ADDENDUM

NO. 4

PROJECT NAME: New Randall Hill Support Center

ADDENDUM DATE: June 23, 2020

C1.04

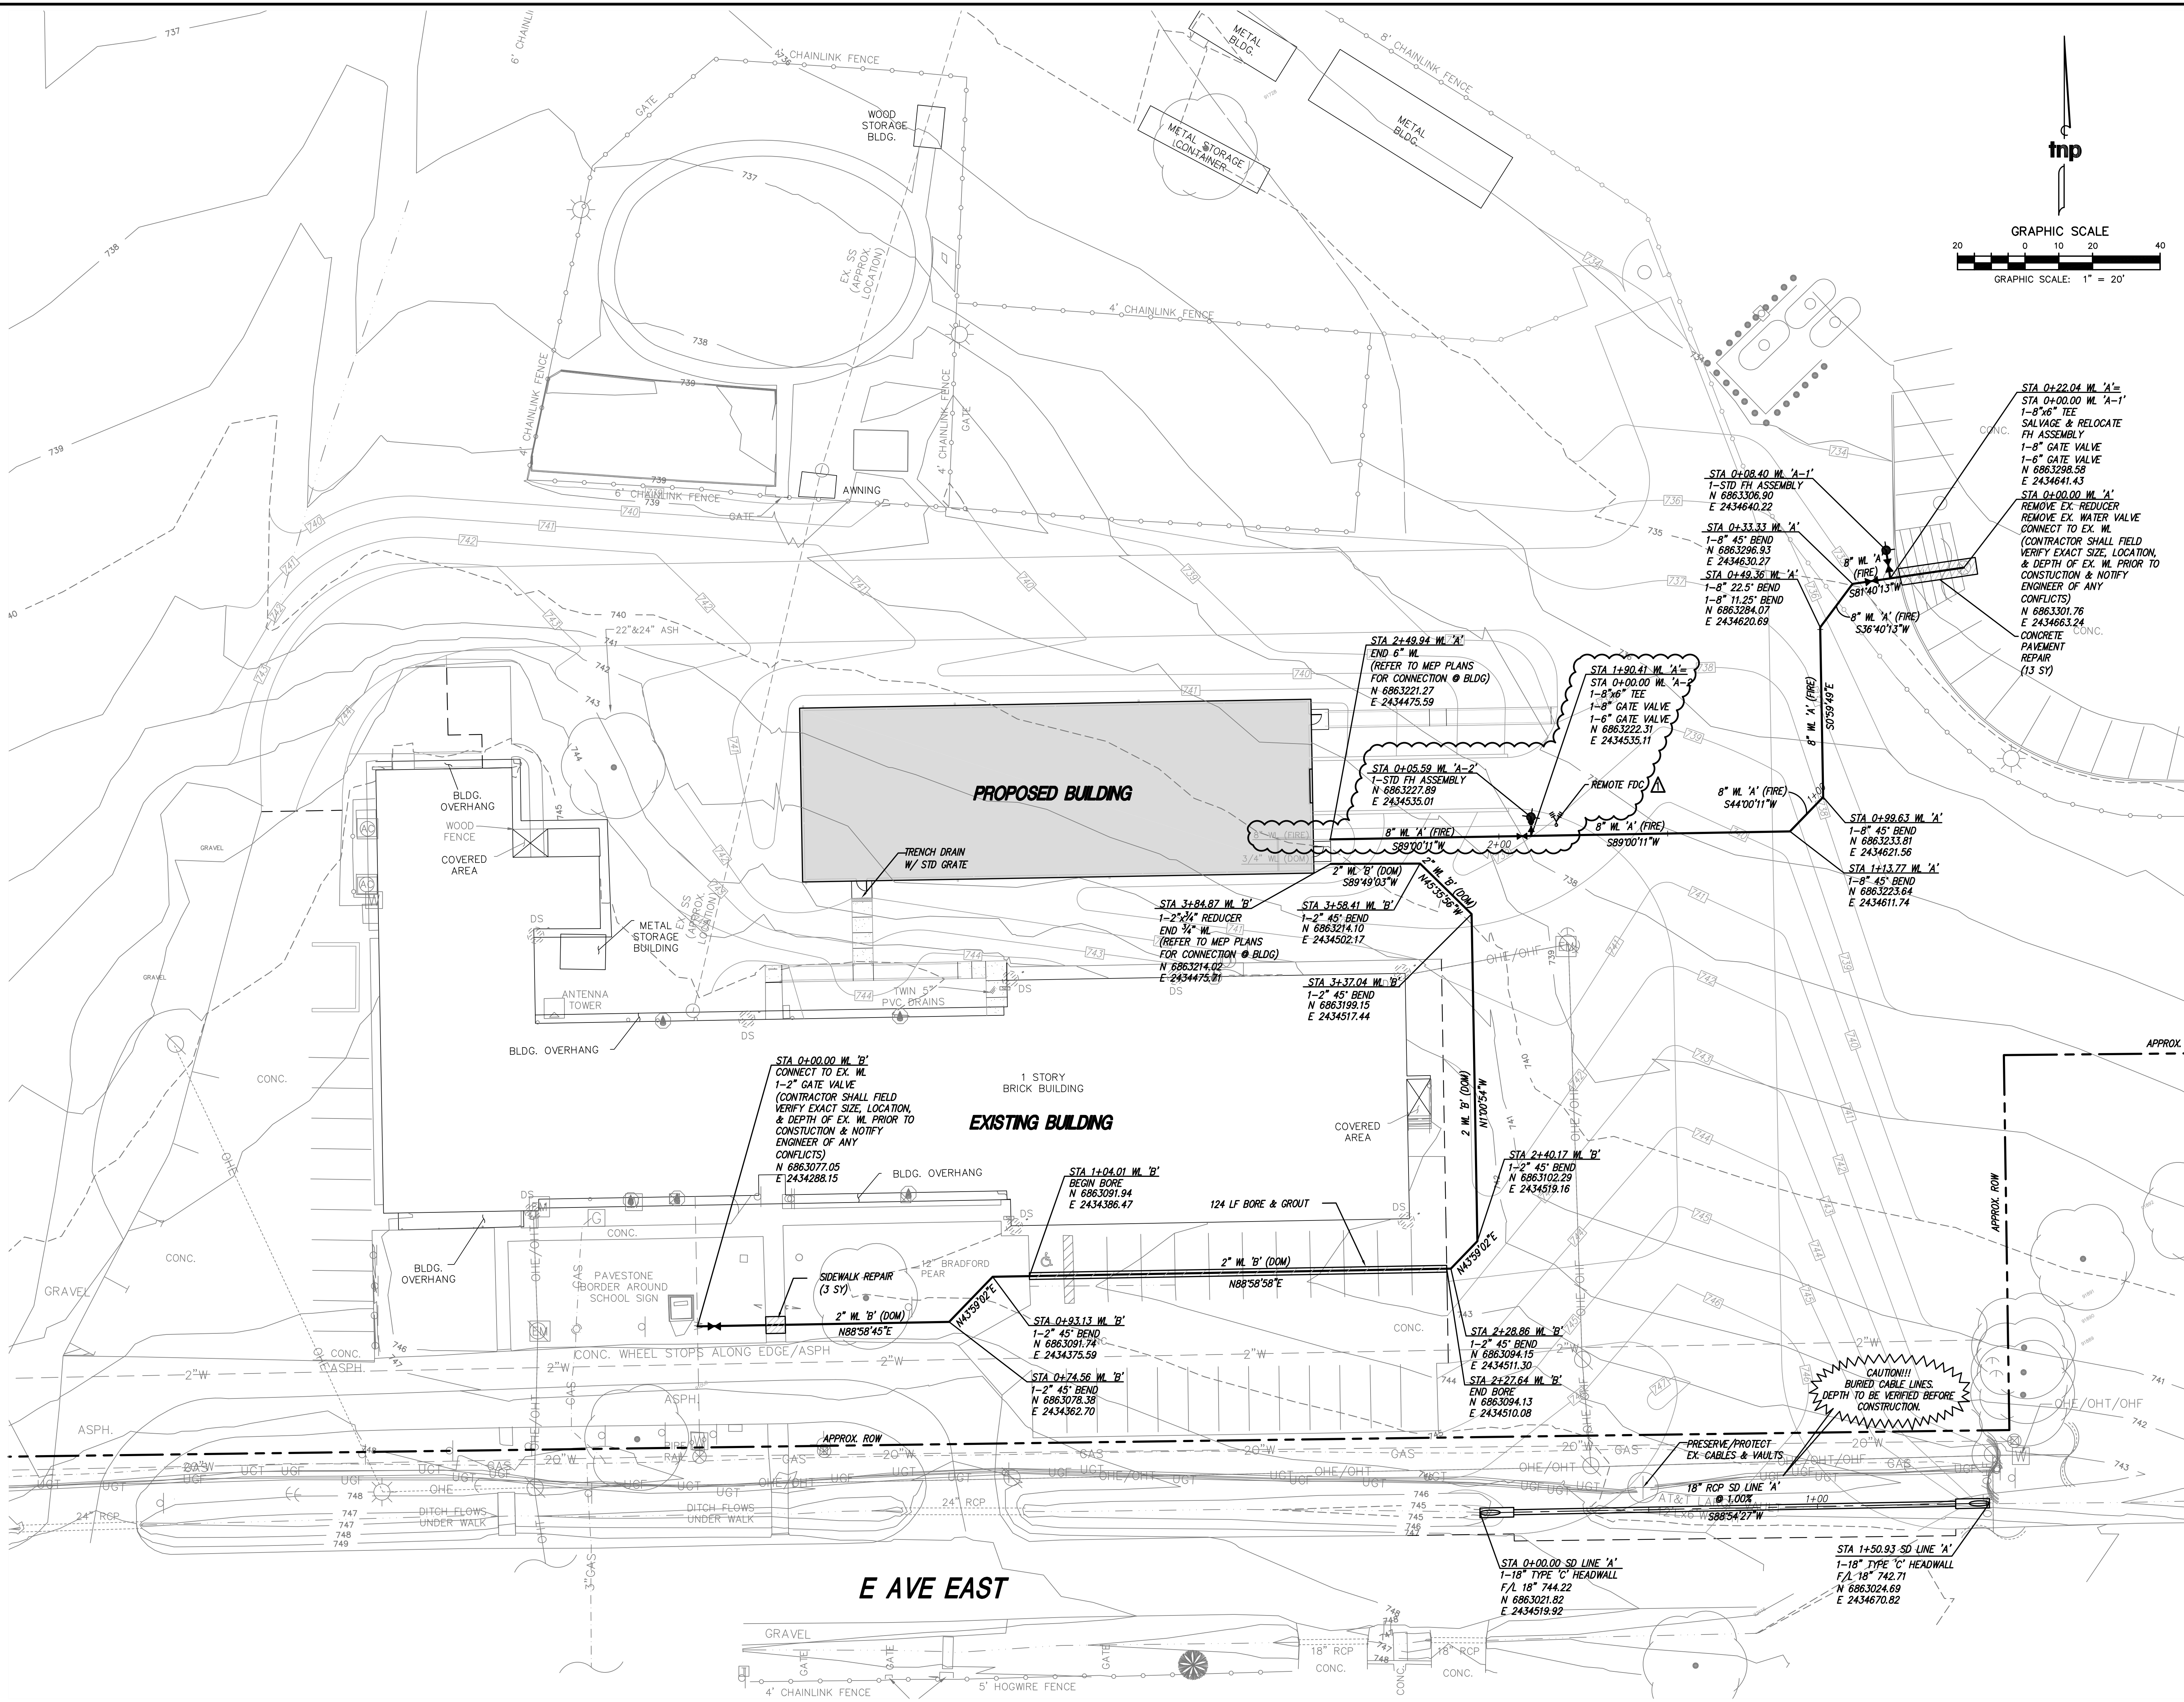
AD No 4, Civil Item 1: To the Drawings, Sheet C1.04, "SITE AND DIMENSIONAL CONTROL PLAN,"

- 1) Revised the location of the FDC on the site plan, per MEP drawings.

PE1.

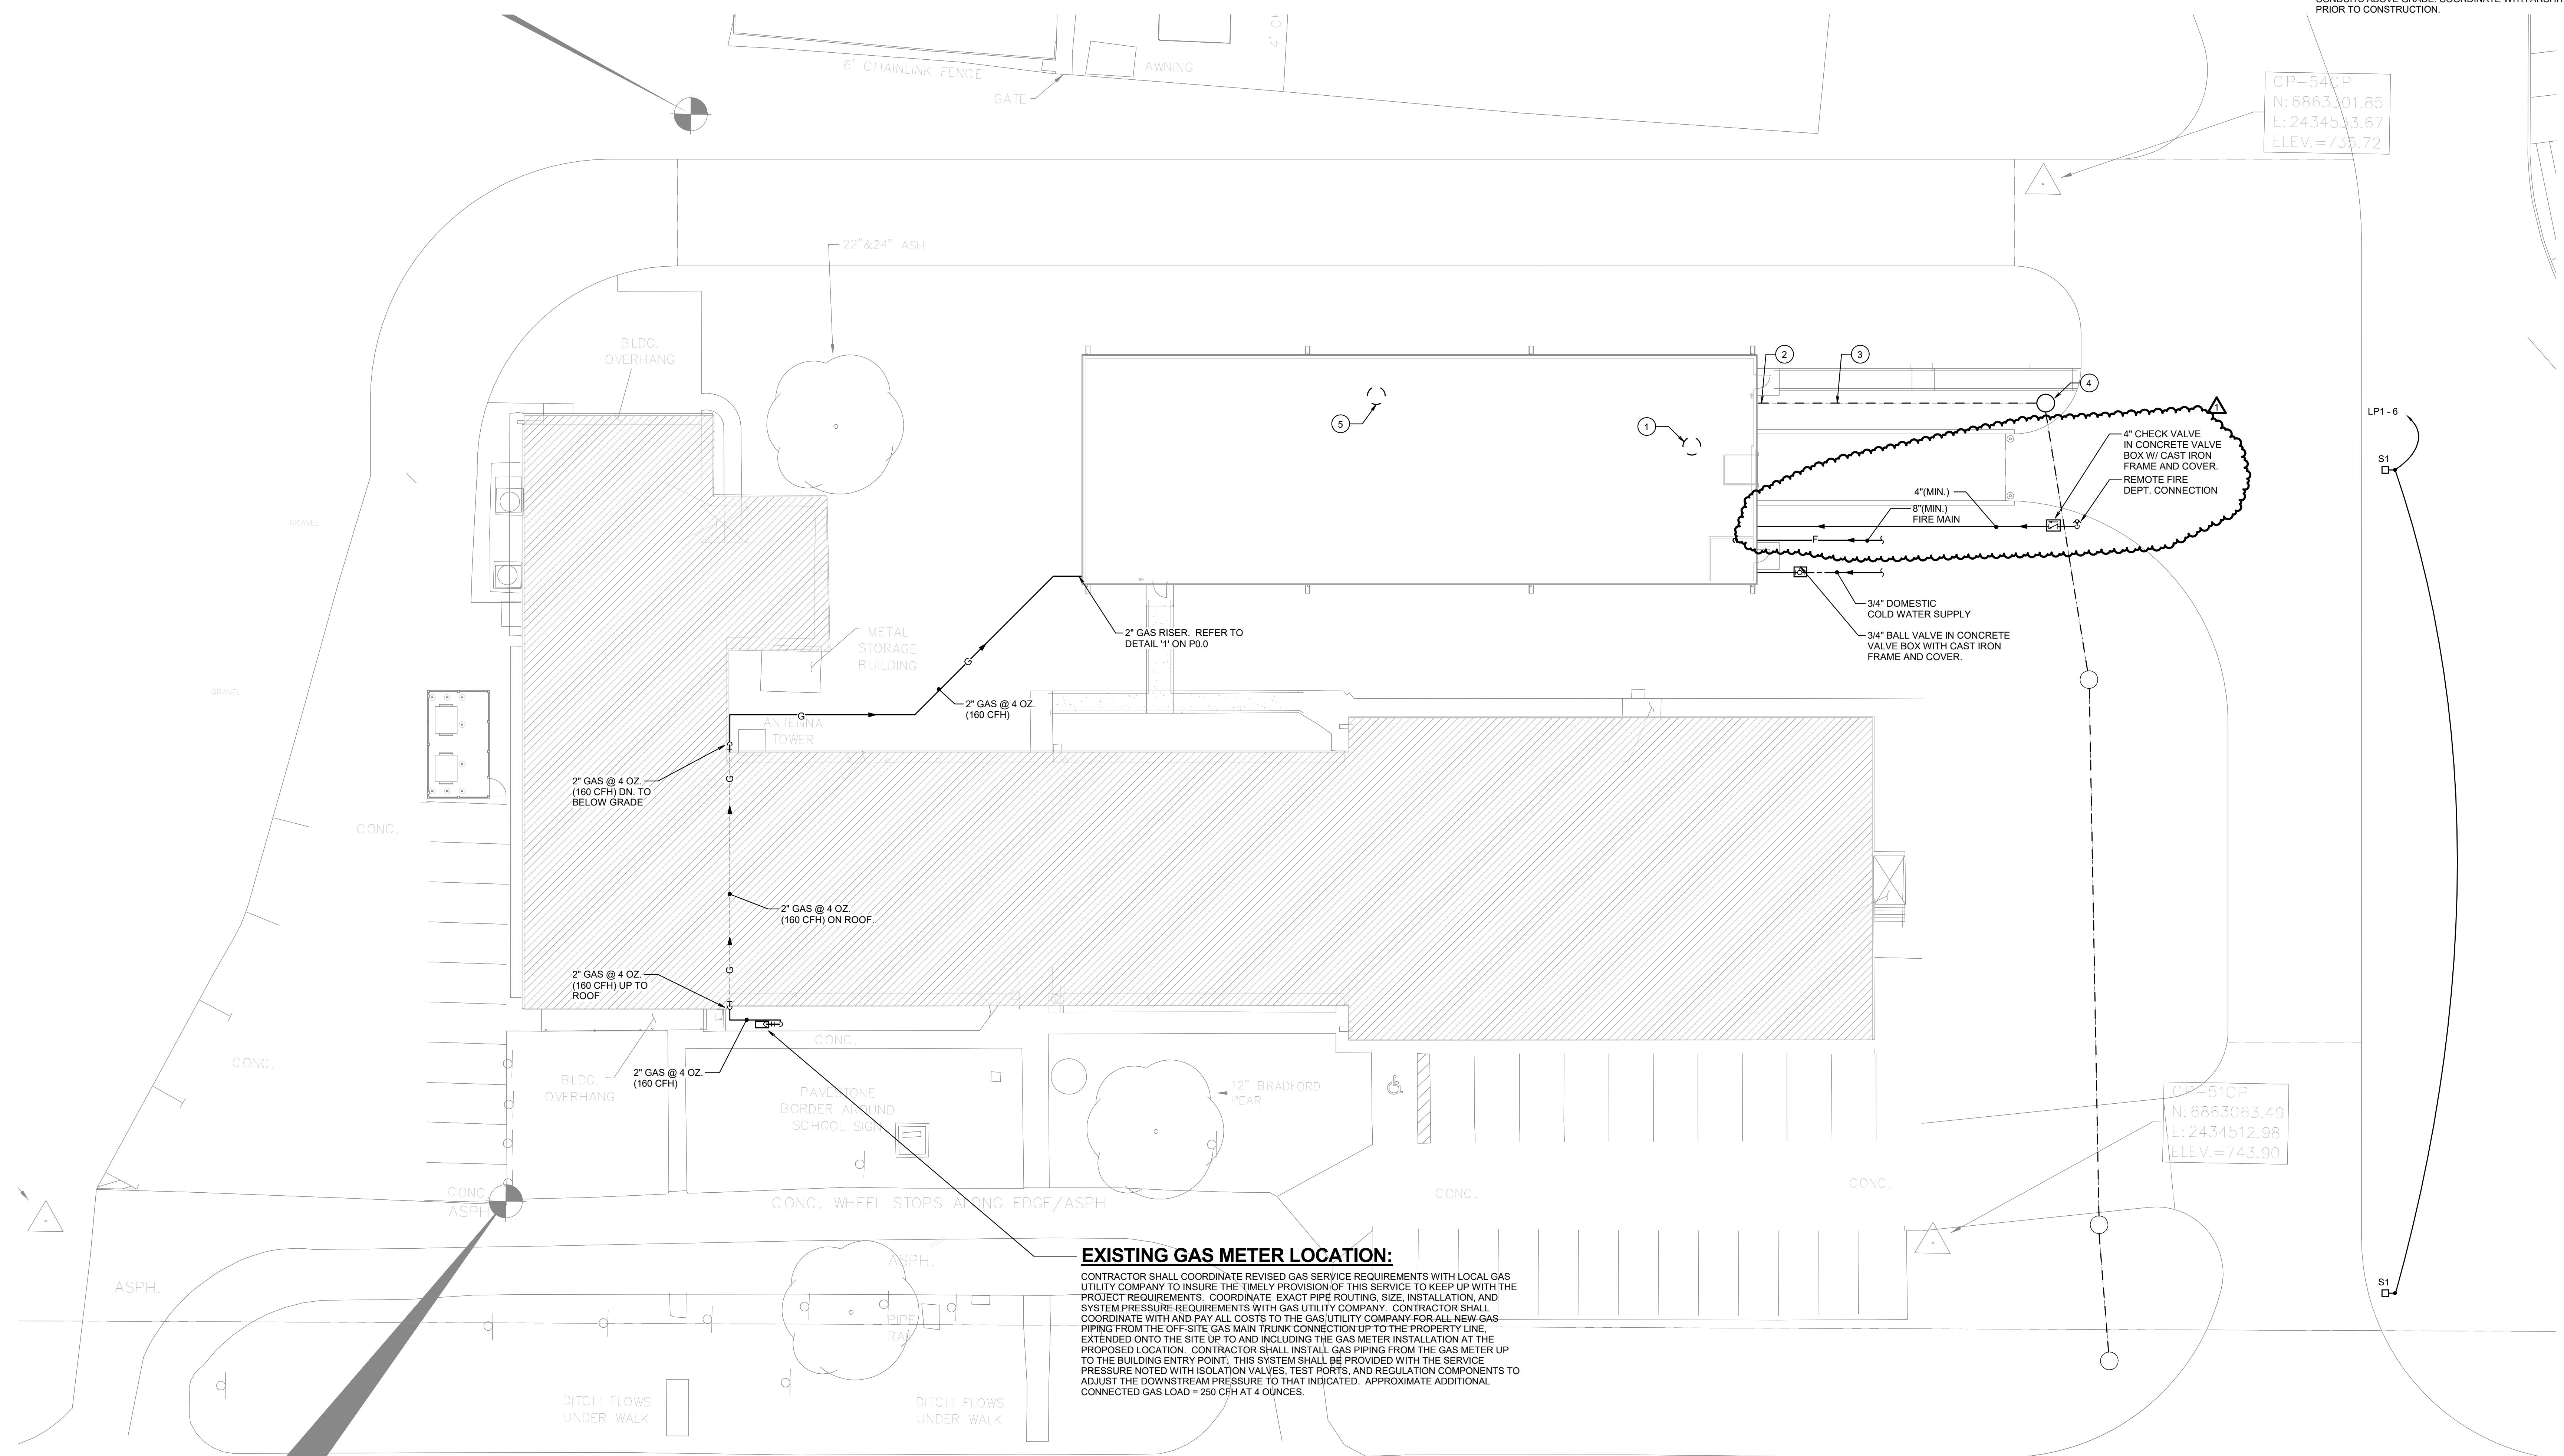
AD No 4, Plb. Item 1: To the Drawings, Sheet MPE1.0, "SITE PLAN - MPE"

- 1) Revised Fire Department Connection to on site remote connection per City of Midlothian.

UNDERFLOOR PLAN -
SECTION 1 - PLUMBING

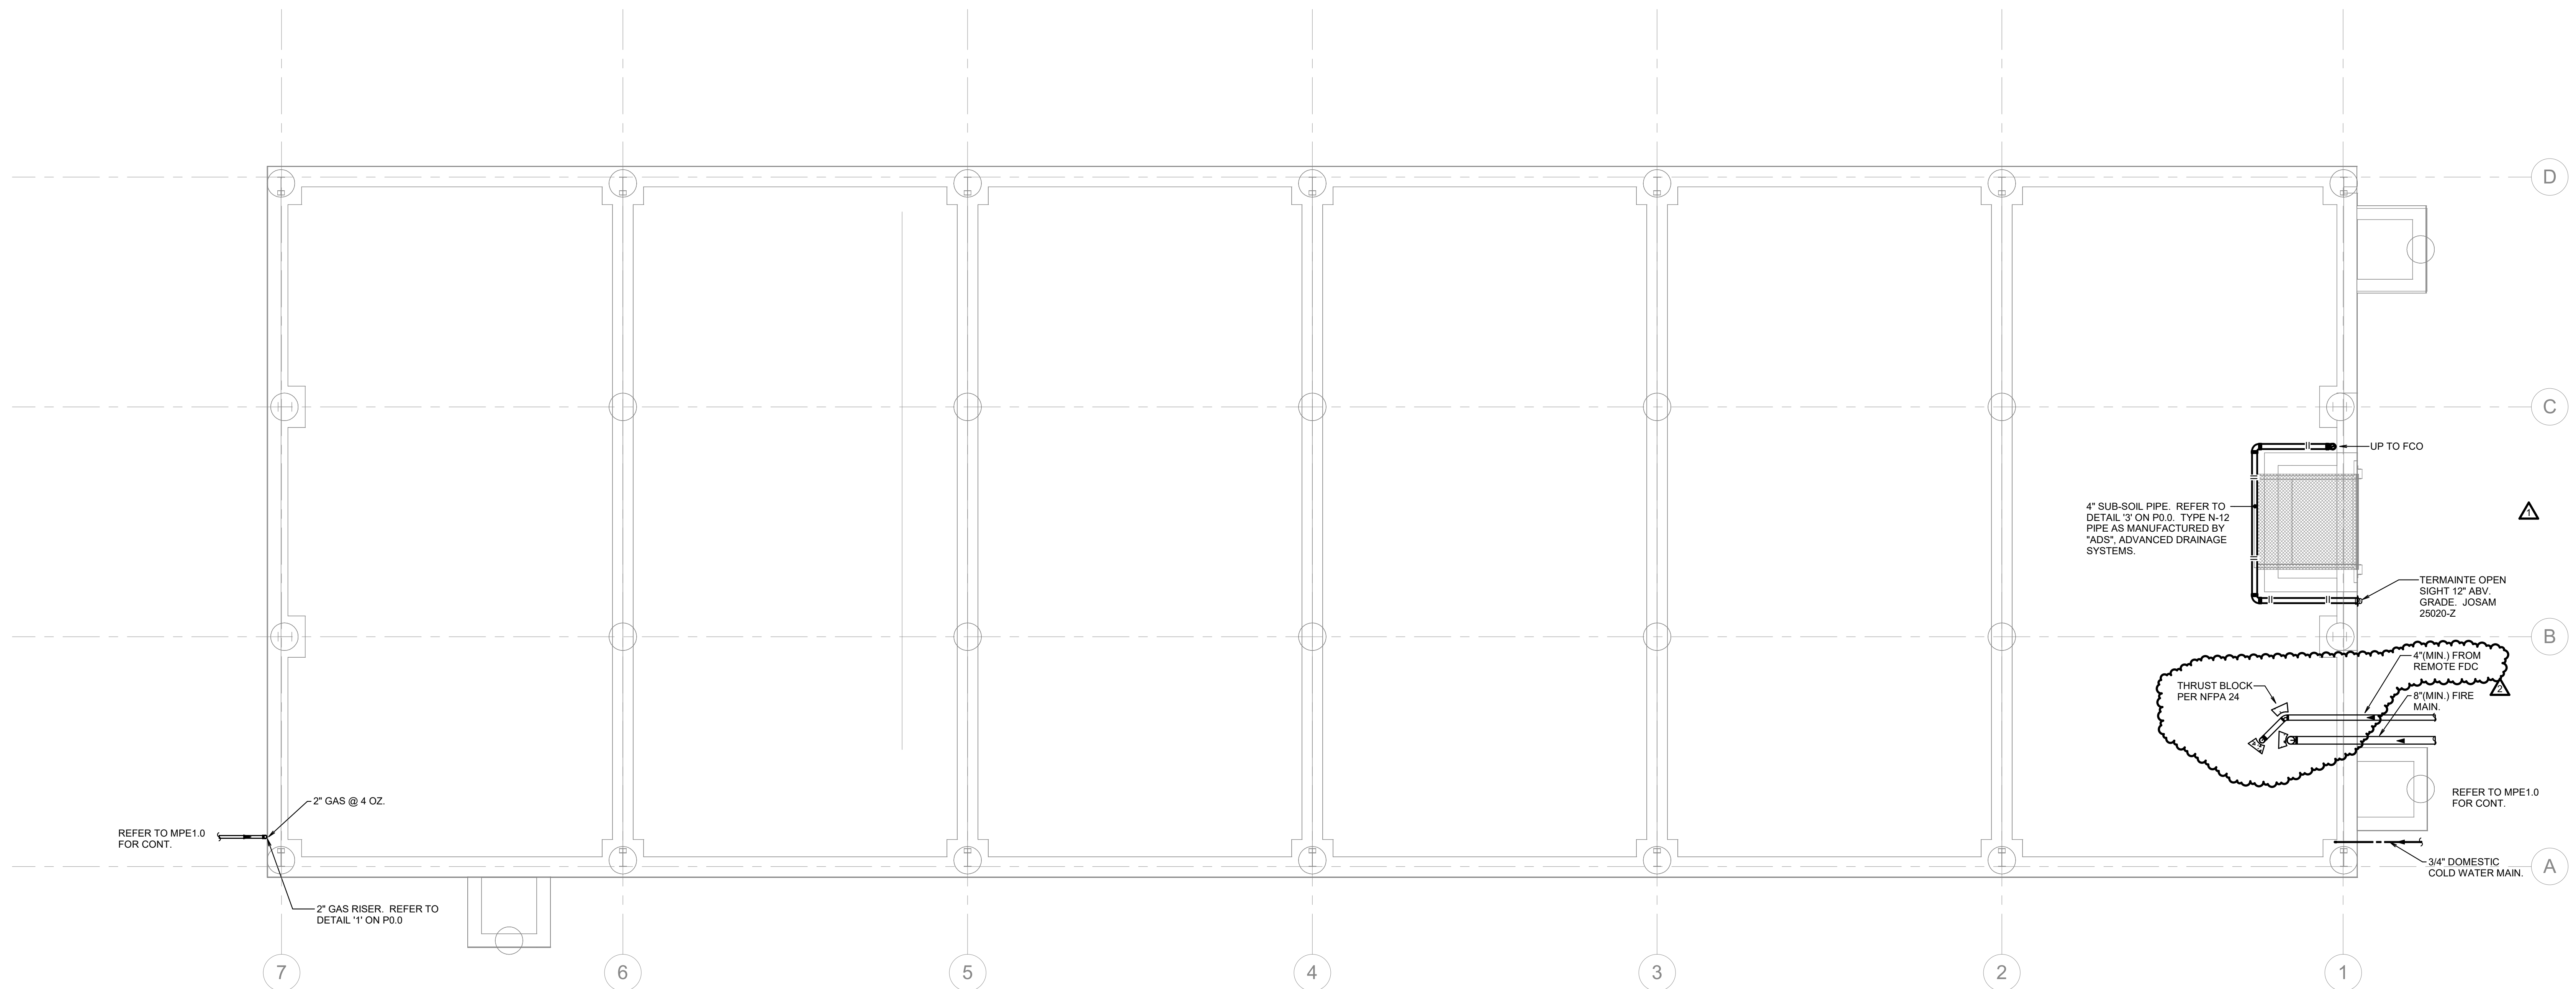
AD No 4, Plb. Item 2: To the Drawings, Sheet P1.1, "UNDERFLOOR PLAN – SECTION 1 - PLUMBING"

- 1) Revised Fire Department Connection to on site remote connection per City of Midlothian.
